Advisory Action Before the Filing of an Appeal Brief	Application No. 09/730,783	Applicant(s) OH ET AL.	
	Examiner Allan Olsen	Art Unit 1763

ADVISORY ACTION

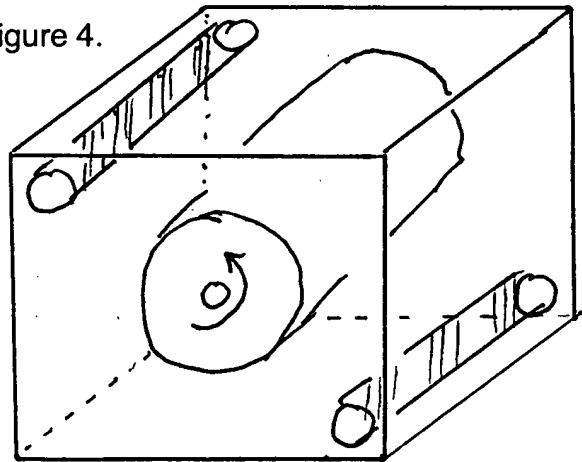
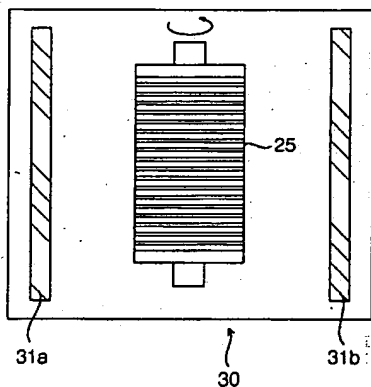
The examiner finds no support for "at a side other than the top or bottom of the immersion tank".

Applicant argues that: "Fig. 4 clearly shows the positions of ultrasonic vibrators 31a and 31b and of intermediate product 25 in the etching tank 30, and that each ultrasonic vibrator 31a or 31b is located at a side of the tank that is not the top side or the bottom side of the tank.

The examiner notes that figure 4 includes a depiction of the etching tank with two ultrasonic vibrators. The figure is a two dimensional representation of a topside view. The figure, as shown below, contains absolutely no information regarding the vertical placement or depth of the ultrasonic vibrators. As such, figure 4 does not support "positioning at least one ultrasonic vibrator in the etching tank at a side other than the top or bottom of the immersion tank".

It should be readily appreciated that the two dimensional topside view shown in figure 4 represents many possible 3-dimensional configurations. For example, the configuration shown below (right side), wherein one ultrasonic vibrator is positioned at the top of the etching tank and one ultrasonic vibrator is positioned at the bottom of the etching tank, is encompassed by the depiction of figure 4.

Applicant's arguments, fourth paragraph, page 4, filed December 15, 2006, with respect to the proper adjustment of the interval between the mask-free parts, have been fully considered and are persuasive. Therefore, this aspect of the rejection under 112 1st, have been withdrawn. However, claims 1-9 remain rejected for the limitation pertaining to the positioning of the ultrasonic vibrators.
